**PREVOST**

# MAINTENANCE INFORMATION

Mi04-17

DATE : SEPTEMBER 2004	SECTION : 22 - HVAC
SUBJECT : ELECTRICAL MOTOR BRUSH CHANGE TEST IN THE EVAPORATOR COMPARTMENT

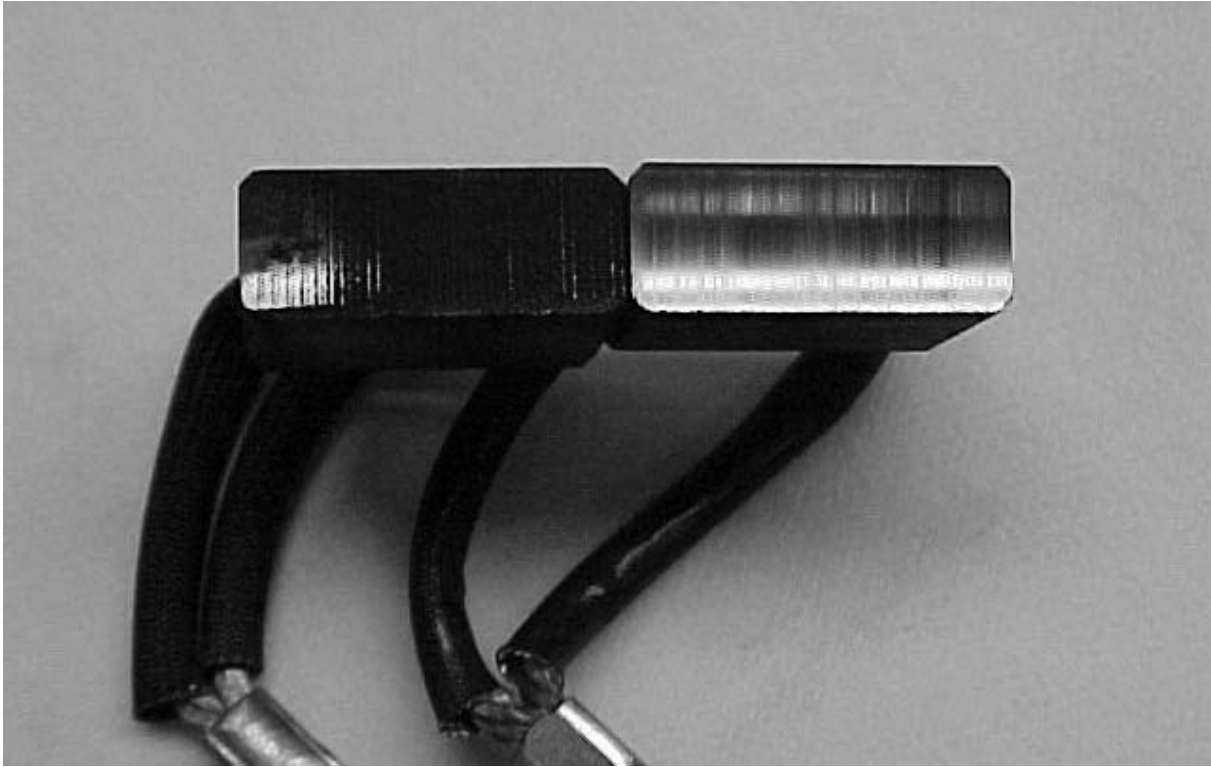
After about 20 minutes of operation, here is the new brush polishing compared to the old one.

*We can see that the polishing is not yet finished but the motor is operating within its parameters.*
